Immingham Green Energy Terminal

9.3 Applicant's Responses to the Examining Authority's First
Written Questions

(Responses to "Q1.5. Biodiversity")

Document Reference: TR030008/EXAM/9.3

Figure 1. Location of the Approach Jetty and Jetty Head.

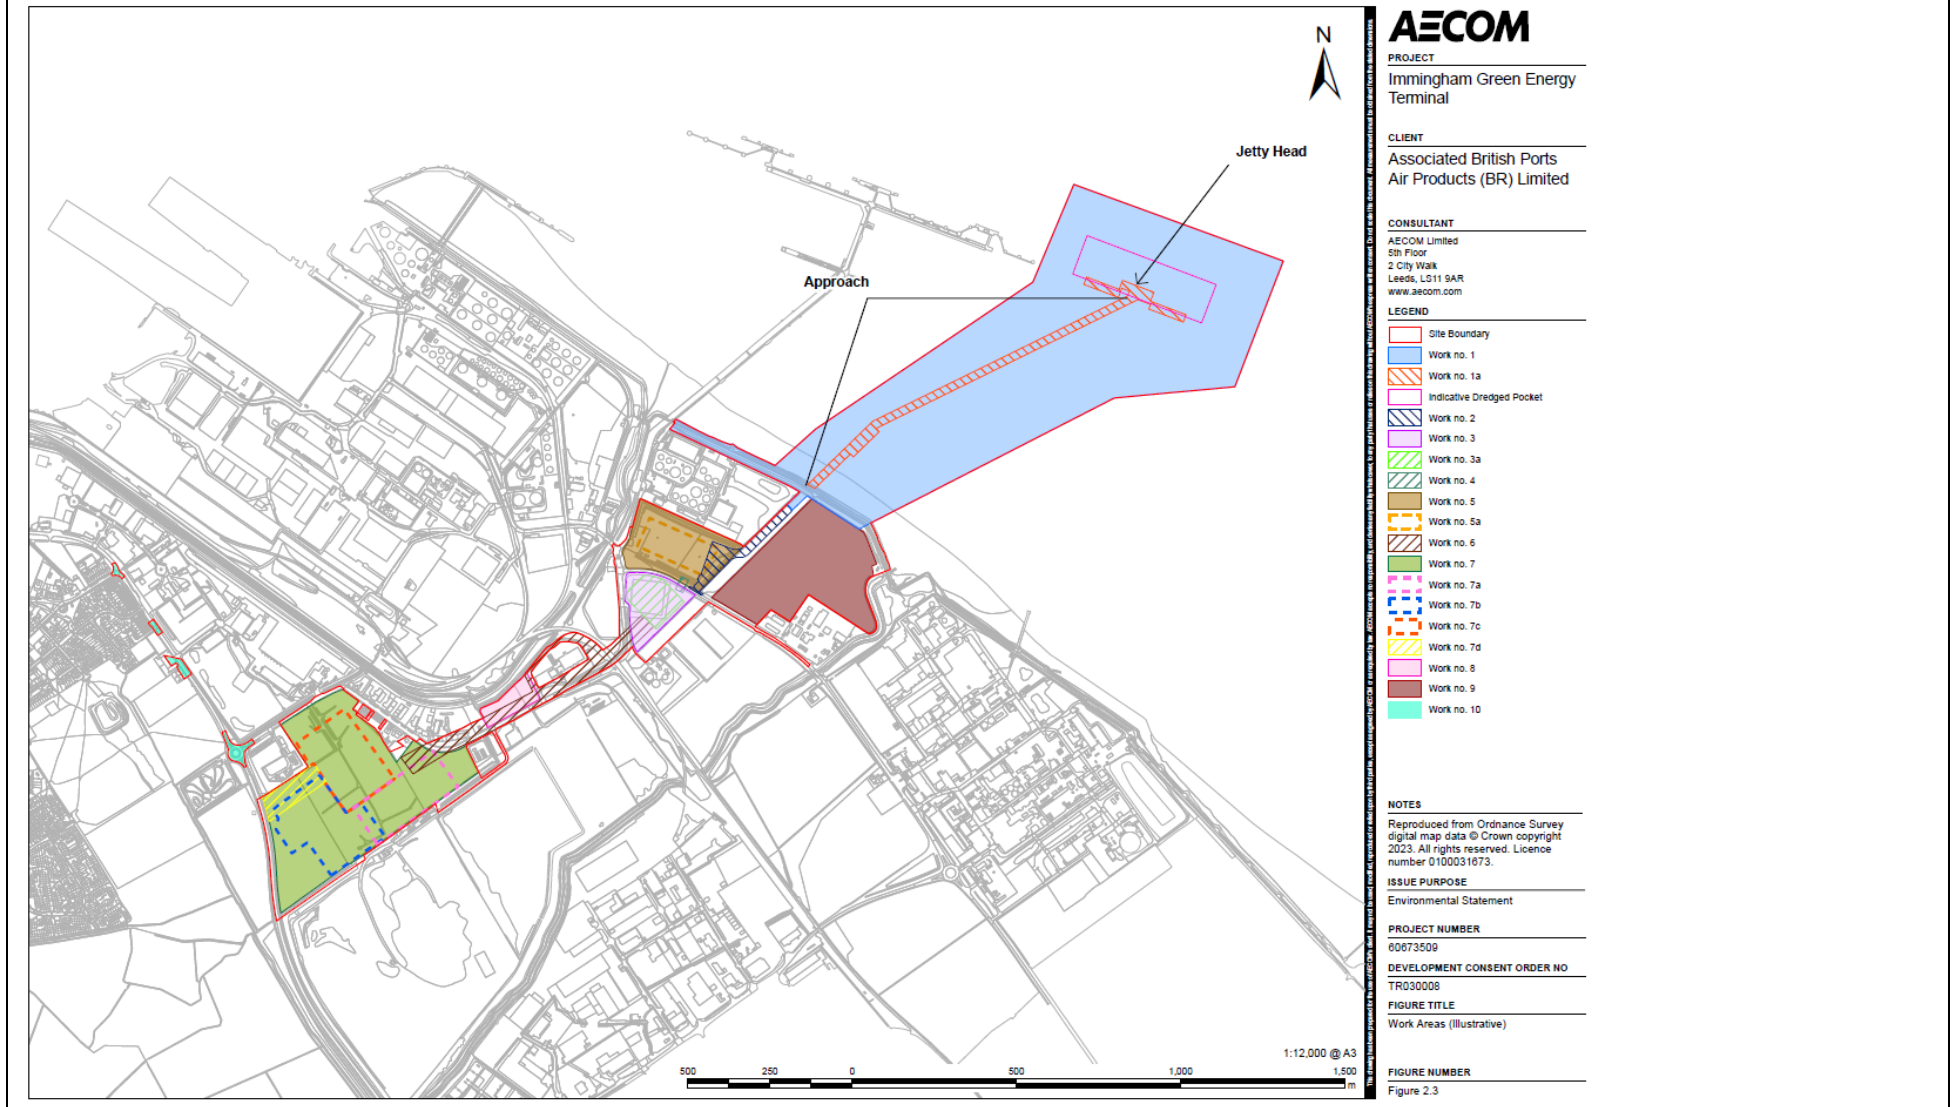
- a) MMO, correct these times in line with the body of your representation
- b) Applicant - Provide an update of the Table shared at ISH3 [EV5-006] [EV5-007] showing the proposed temporal and seasonal restrictions.
- c) Applicant – From this Table, signpost where the ">200m" information is provided within the ES.
- d) Applicant – With this Table, include a pictorial description of the limits of the "Jetty Head" and "Approach Jetty".
- e) Applicant and MMO – confirm whether the limits shown on this table have been agreed.

Figure 1 illustrates the location of the jetty head and approach jetty.

Figure 3: North Beck Drain looking downstream from Laporte Road towards the sea wall

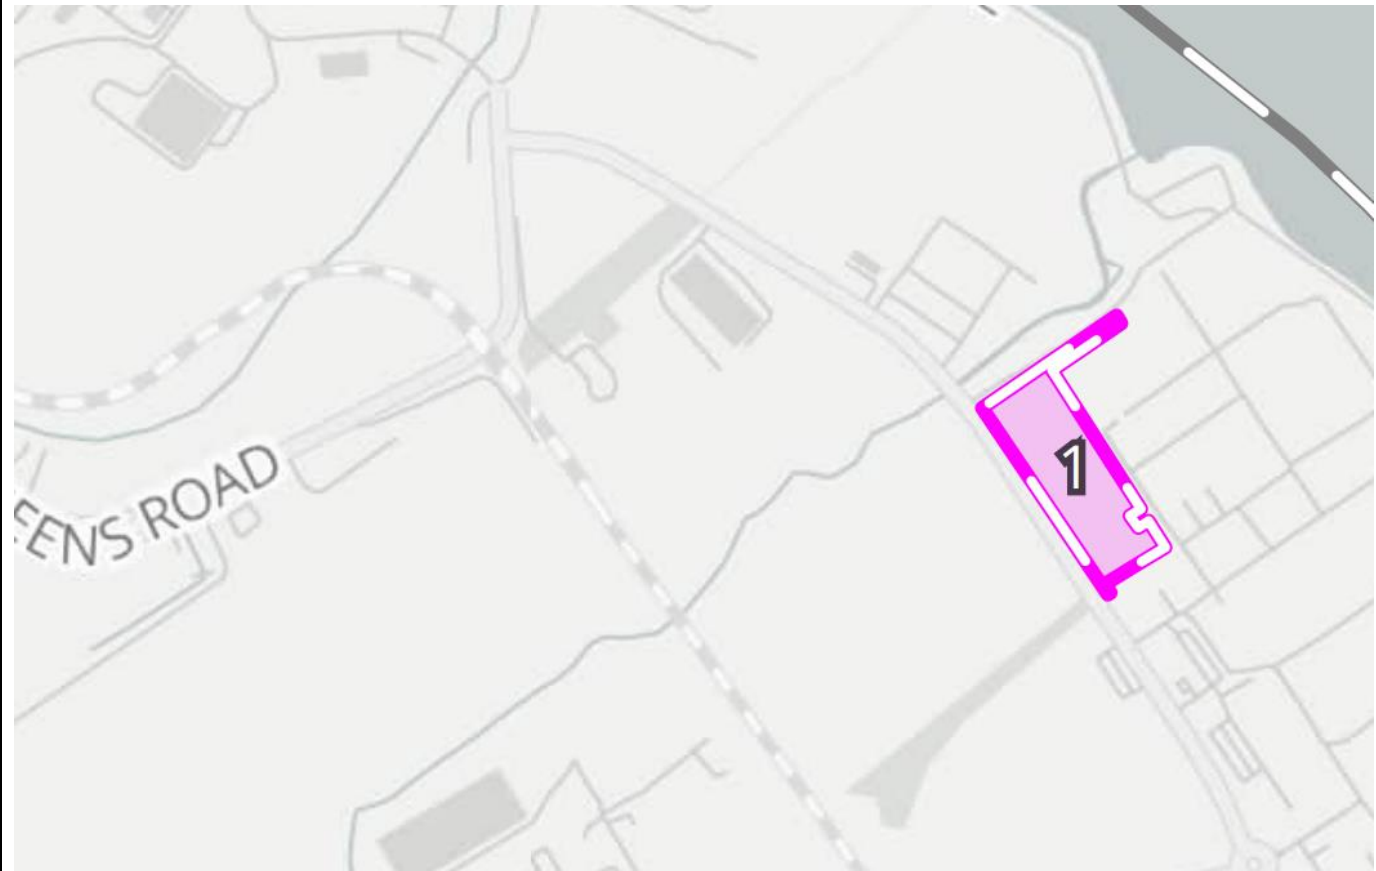
Question	Response
<p>North Beck Drain</p> <p>The ES notes that North Beck Drain may provide a suitable foraging and resting habitat for otter [APP-050, Paragraph 8.6.24] and the same for water vole [APP-050, Paragraph 8.6.31]. Both paragraphs then state that survey was not undertaken because the drain is outside the boundary and will not be directly impacted by the Proposed Development. However, findings include several adverse impacts construction impacts and effects, ranging from negligible, minor adverse and moderate adverse [APP-060, Section 18.8.]. Explain why these impacts have not been considered in relation to the potential for protected species habitat.</p>	<p>The section of North Beck Drain along the south-eastern boundary of the Temporary Compound Area (Work No. 9) is referred to in Paragraph 8.6.24 and Paragraph 8.6.31 [APP-050] and flows from Laporte Road down to its outlet through the sea wall. Given its critical drainage function, it is maintained to a high hydrological standard by the Environment Agency with regularly short mown banks as can be seen from Laporte Road (see Figure 3).</p> <p>A re-examination of North Beck Drain on 2 February 2024 determined that the references to otter and water vole in Paragraph 8.6.24 and Paragraph 8.6.31 respectively of Environmental Statement ("ES") Chapter 8: Nature Conservation (Terrestrial Ecology) [APP-050], in fact relate to the ditch running parallel to and south east of North Beck Drain which borders the Laporte Road Brownfield Site Local Wildlife Site and is known to support water vole. This ditch is located along the northern edge of the pink polygon in the image below (Figure 2), which is taken from the Preliminary Ecological Appraisal Report [APP-181] and which shows the location of Laporte Road Brownfield Site Local Wildlife Site. The ditch is offset from the North Beck Drain, which is the much more prominent watercourse to the north of the pink polygon (Figure 2).</p>

Based on the relatively low value of the habitats (see **Figure 3**, which shows no substantive emergent or marginal vegetation), any water voles or otters using the North Beck Drain, are expected to use the drain to disperse through the landscape rather than the drain supporting any resident populations. Any possible reduction in water quality, as a result of such indirect effects would not be expected to impact this dispersal function. Similarly, any slightly increased local flood risk or any temporary overwhelming of the drainage network would not be expected to impact these aquatic animals, which are well adapted to short term variations in water levels.

Figure 5: Proposed Woodland Enhancement (Woodland Replacement Planting)

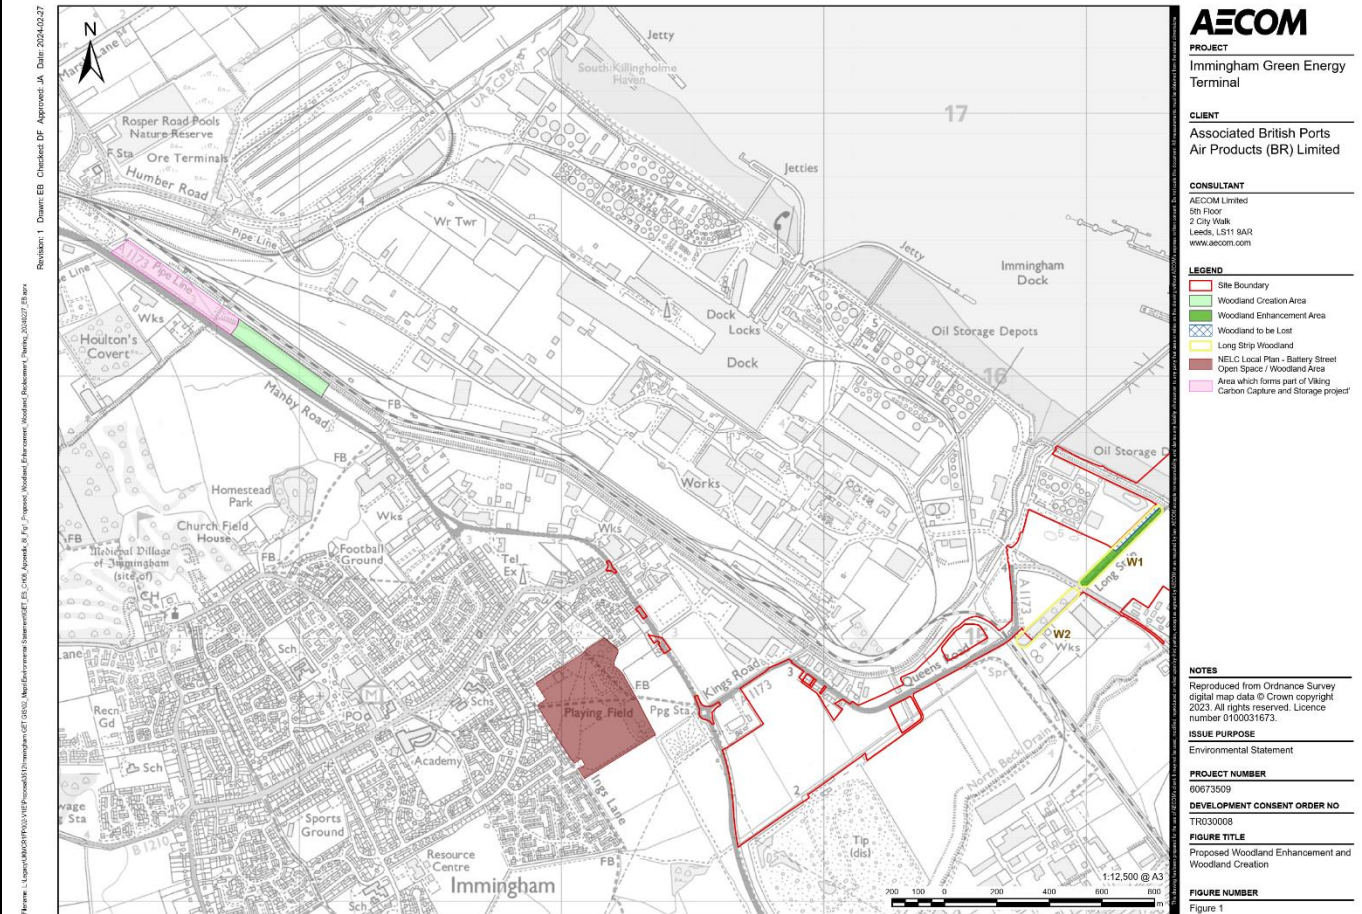
Question	Response
<p>Potential Land Take by Viking CCS Project</p> <p>Further to the Action Point noted at ISH2 [EV4-006] [EV4-007], a plan was shown at ISH2 that indicated the potential land take required should the Viking CCS project be granted DCO and the implications that this would have on the land availability for compensatory woodland for IGET. This plan and an explanatory note on the potential impacts on the Proposed Development is to be submitted into the Examination.</p>	<p>The plan will form part of the Woodland Compensation Plan, the final version of which is intended to be submitted and approved under Requirement 11 of Schedule 2 of the draft Development Consent Order [PDA-004] and will be produced in accordance with the Outline Woodland Compensation Strategy [APP-224]. The Draft Woodland Compensation Plan [TR030008/EXAM/9.34] submitted at Deadline 1 is the first step in developing the final Woodland Compensation Plan, to enable the requirement to be discharged.</p> <p>The explanatory note is provided by the text below:</p> <p>The area of blue diagonal shading on the plan shows the overlap between (i) the area originally proposed for woodland compensation, shown to its full extent in green, which was included in the Outline Woodland Compensation Strategy [APP-224]; and (ii) that part of the application boundary for the Viking CCS Pipeline application for development consent (PINS Reference: EN070008) (the “Viking CCS Application”) which overlaps with the same area.</p> <p>Assuming the Viking CCS Application is consented to the full extent of its proposed order limits, the effect of the overlap is to reduce the area available for long-term woodland compensatory</p>

<p>planting for the Project. The Draft Woodland Compensation Plan [TR030008/EXAM/9.34] submitted at Deadline 1 has been taken forward on the basis that only the reduced area would be available for woodland compensation. No other impacts of the Viking CCS proposals on the new woodland planting in this location, other than this reduced extent for compensatory planting, are expected. For this reason and following discussions with North East Lincolnshire Council ("NELC"), the Applicant is evaluating the approach to delivering part of the compensatory planting on a separate area of land, off Battery Street, at the southern edge of Immingham. The location for this is shown as an area for enhancement for nature conservation in the local plan, viewable on the inset maps¹, and is shown by the green-coloured polygon on the plan provided in the Draft Woodland Compensation Plan [TR030008/EXAM/9.34].</p> <p>References:</p> <p>¹ North East Lincolnshire Council (2018). North East Lincolnshire Local Plan 2013 to 2032 – Inset Maps. [Online] https://www.nelincs.gov.uk/assets/uploads/2018/05/20180322-PolicyMapInsetMaps-WEB-1.pdf (accessed March 2024).</p>

Figure 6: Long Strip Tree Preservation Order (Source: Plan extracted from Tree Preservation Order)

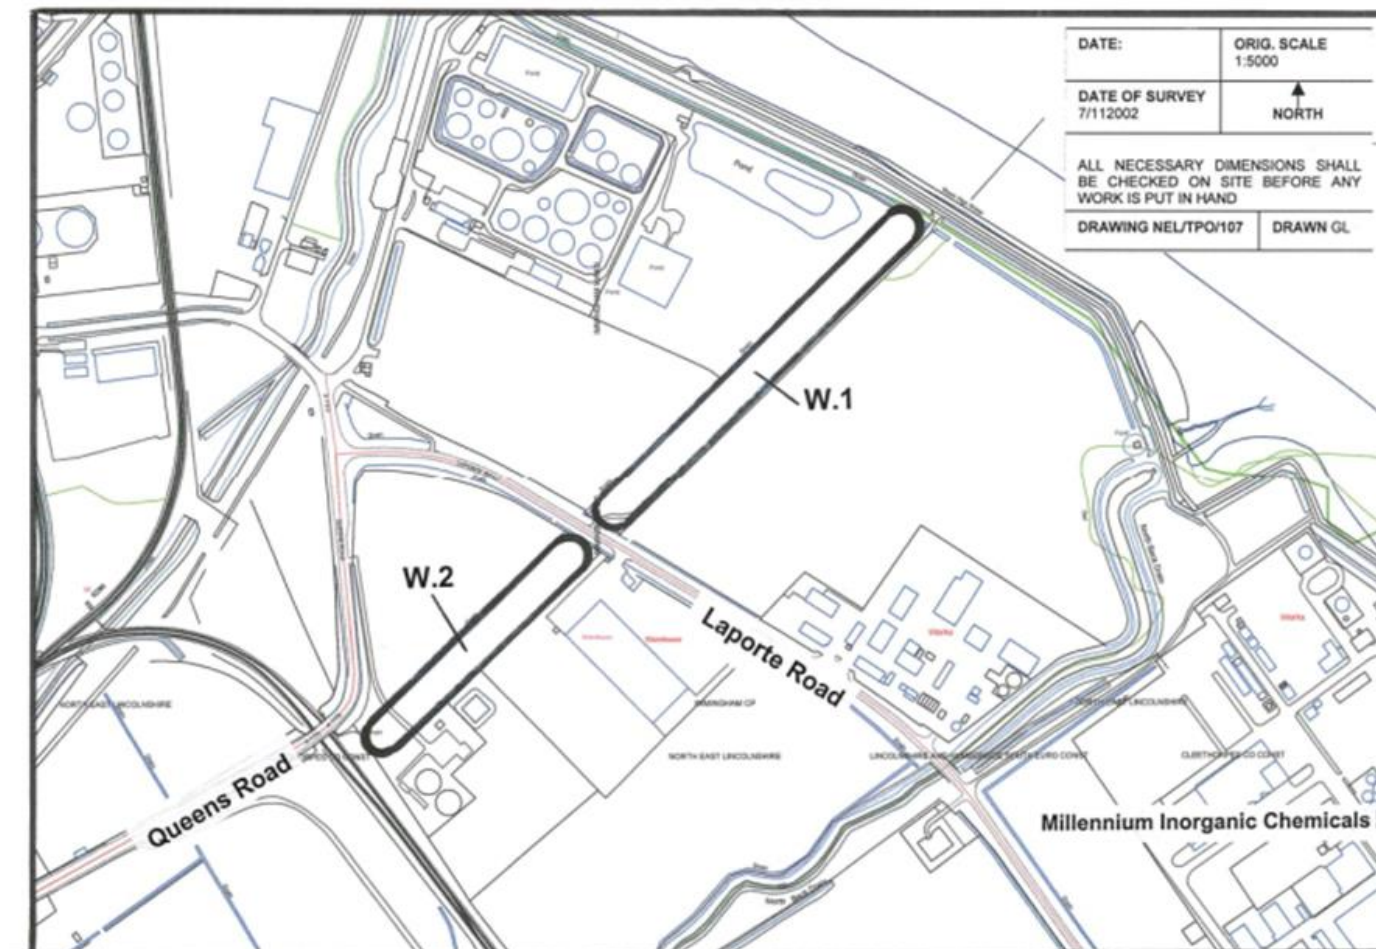
Question	Response
<p>Proposed enhancements to south section of Long Strip through IERRT</p> <p>ES [APP-224, section 1.1.6] notes proposed enhancements to the southern section of the Long Strip as part of the adjacent IERRT that is currently in Examination and for which you are the Applicant. In order to gain a complete understanding of the proposals for the Long Strip, provide the details of this proposed enhancement. See related question in the Cumulative Effects and In-combination Effects section.</p>	<p>The details of proposals for the enhancement of the southern section of the Long Strip woodland (W.2 as shown on the TPO schedule in Figure 6 below) that form part of the Immingham Eastern Ro-Ro Terminal ("IERRT") project are provided in the IERRT Woodland Enhancement and Management Plan ("WEMP"), produced in December 2022¹. The enhancement of W.2 relates solely to the IERRT proposals. The inclusion of the same area within the Order Limits of the Project is solely to ensure that existing informal access through this woodland can be temporarily removed to enable the safe construction of the adjacent works, as explained in Paragraph 2.5.41(c) within Environmental Statement Chapter 2: The Project [APP-044].</p> <p>The Outline Woodland Compensation Strategy [APP-224] and the Draft Woodland Compensation Plan [TR030008/EXAM/9.34], which is submitted at Deadline 1, includes enhancement measures for the retained part of section W.1 of the woodland and follows a similar programme of woodland enhancement and management as to those of the south section of the Long Strip woodland (section W.2 of the TPO) that was developed and agreed with NELC in the IERRT WEMP to provide ecological enhancements in connection with the IERRT scheme. The measures agreed for the IERRT scheme involved removal of localised areas of dense scrub to open up the canopy and encourage the natural development of a more diverse woodland ground flora.</p>
